STAFF KEI OKT			
Address:	29 West Kirke Street, Chevy Chase	Meeting Date:	9/11/2019	
<b>Resource:</b>	Outstanding Resource Chevy Chase Village Historic District	<b>Report Date:</b>	9/4/2019	
	Chevy Chase vinage filstoric District	<b>Public Notice:</b>	8/28/2019	
Applicant:	Katy & Bryan Anderson (Chris Snowber, Architect)	Tax Credit:	N/A	
<b>Review:</b>	HAWP	Staff:	Michael Kyne	
Case Number:	35/13-19Q REVISION			
PROPOSAL:	Screened-in porch alterations and new construction	on

# MONTGOMERY COUNTY HISTORIC PRESERVATION COMMISSION STAFF REPORT

### Anderson Residence

### Revision Narrative #1 (08/26/2019)

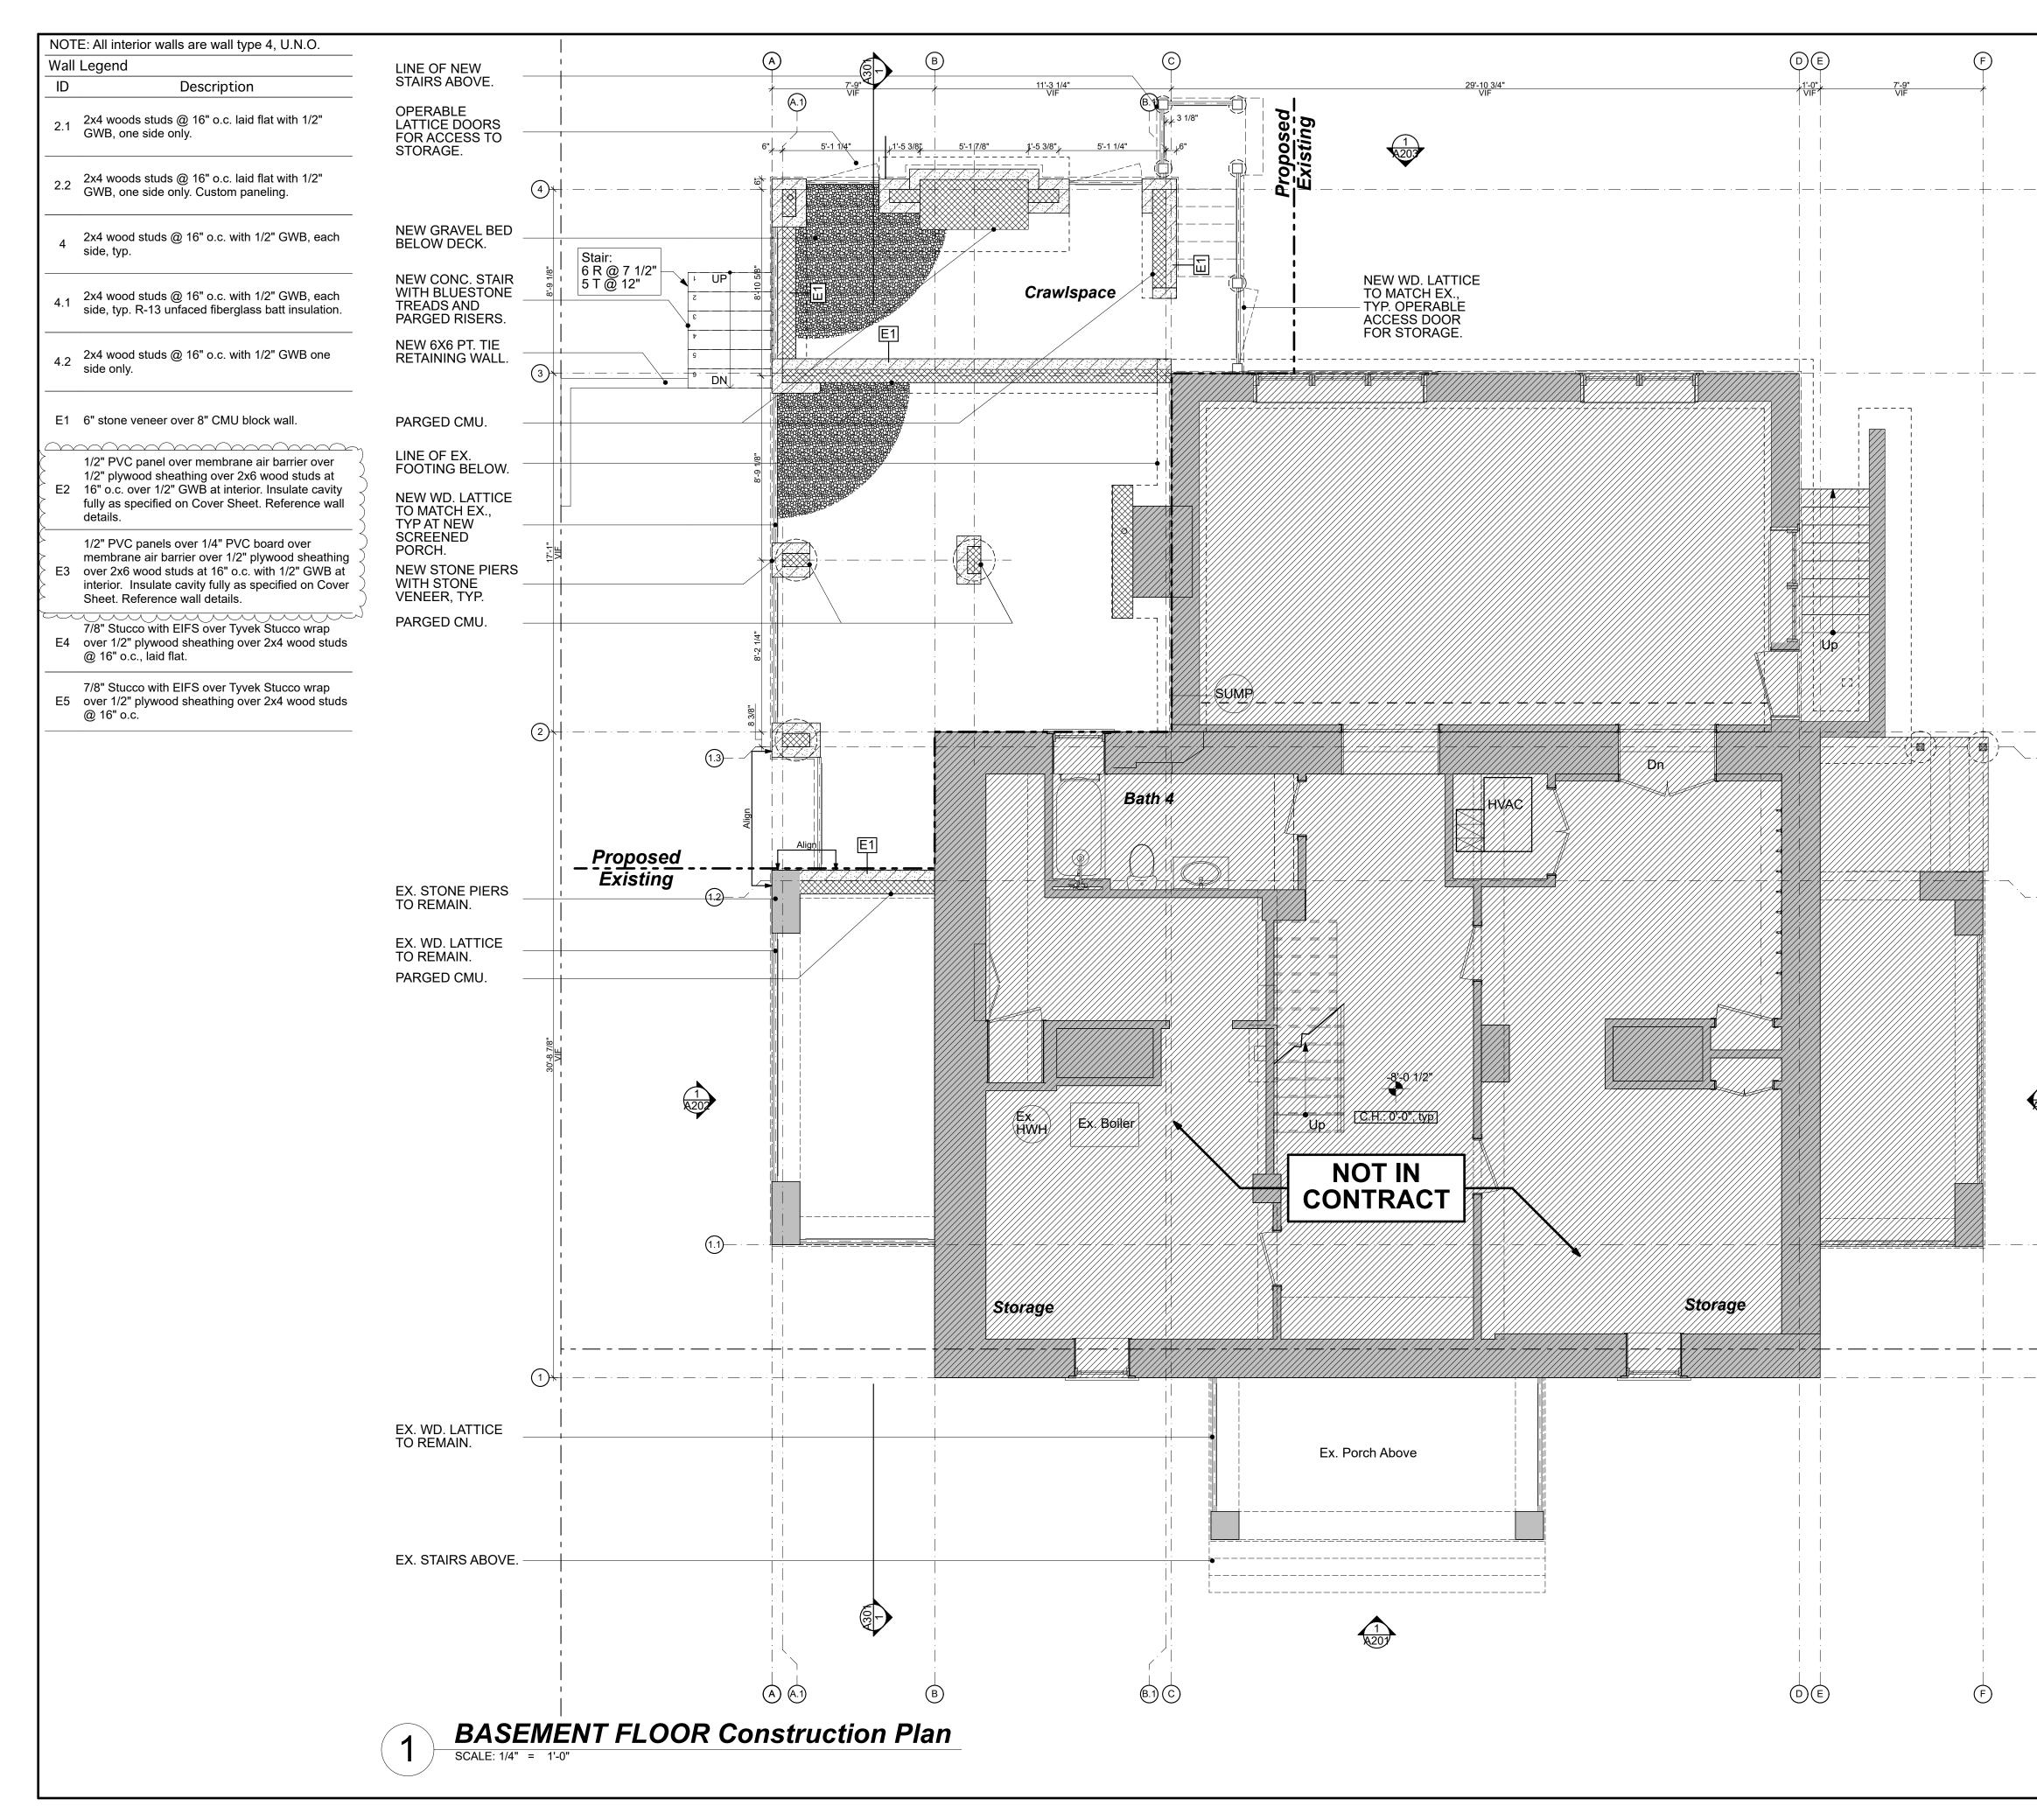
A102	1	The railing at the new exterior stair is revised to PVC. The risers at the existing front covered porch are revised to painted PVC.
A103	1	The existing roof over the existing west bay is revised from 'existing to remain' to new TPO roofing membrane. The new roof over the new screened porch is revised from flat-seamed copper roof to new TPO roofing membrane.
A201	1	The existing roof over the existing west bay is revised from 'existing to remain' to new TPO roofing membrane. The new exterior wall finish at the west bay is revised from wood to PVC exterior panels. The risers at the existing front covered porch are revised to painted PVC.
A202	1	The new roof over the new screened porch is revised from flat-seamed copper roof to new TPO roofing membrane. The new screened porch columns are revised from wood to painted PVC wrapped wood posts. An intermediate PVC or wood wrapped steel post is added to the screened porch railing system for structural support to meet railing code requirements. The railing at the new exterior stair is revised to PVC. The new exterior wall finish at the west bay is revised from wood to PVC exterior panels.

1 North (REAR) Elevation, Proposed

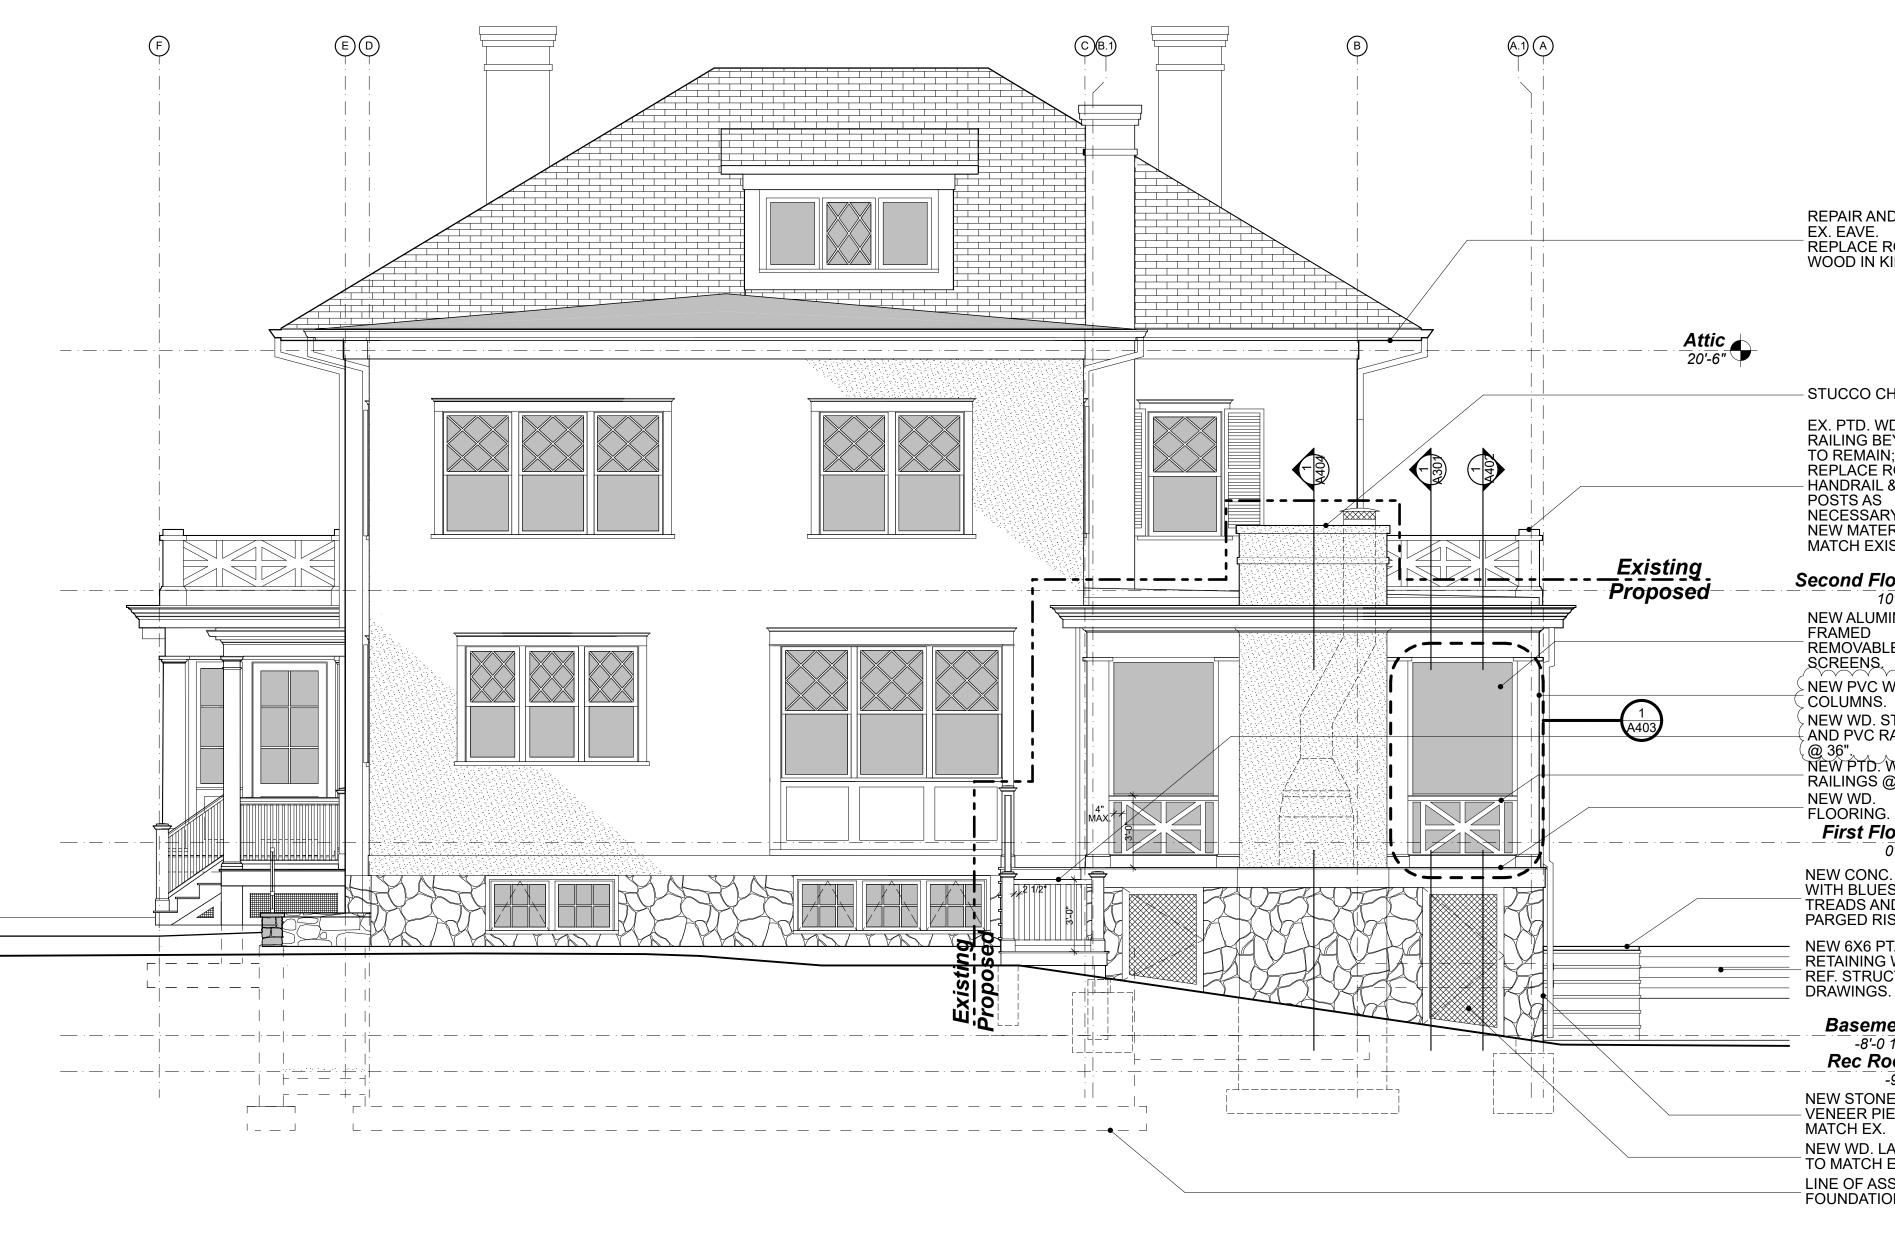
A203	1	The new screened porch columns are revised from wood to painted PVC wrapped wood posts. The railing at the new exterior stair is revised to PVC.
A204	1	The new screened porch columns are revised from wood to painted PVC wrapped wood posts. The railing at the new exterior stair is revised to PVC.
A401	2, 3	The existing roof over the west bay is revised from 'existing to remain' to new TPO roofing membrane. The new exterior wall finish at the west bay is revised from wood to PVC exterior panels. The west bay skirtboard is revised from wood to wood or PVC.
A402	1	The new screened porch soffit and entablature are revised from wood to painted PVC. The new screened porch skirtboard is revised from wood to wood or PVC.
	2	An intermediate PVC or wood wrapped steel post is added to the screened porch railing system for structural support to meet railing code requirements. The new screened porch skirtboard is revised from wood to wood or PVC.
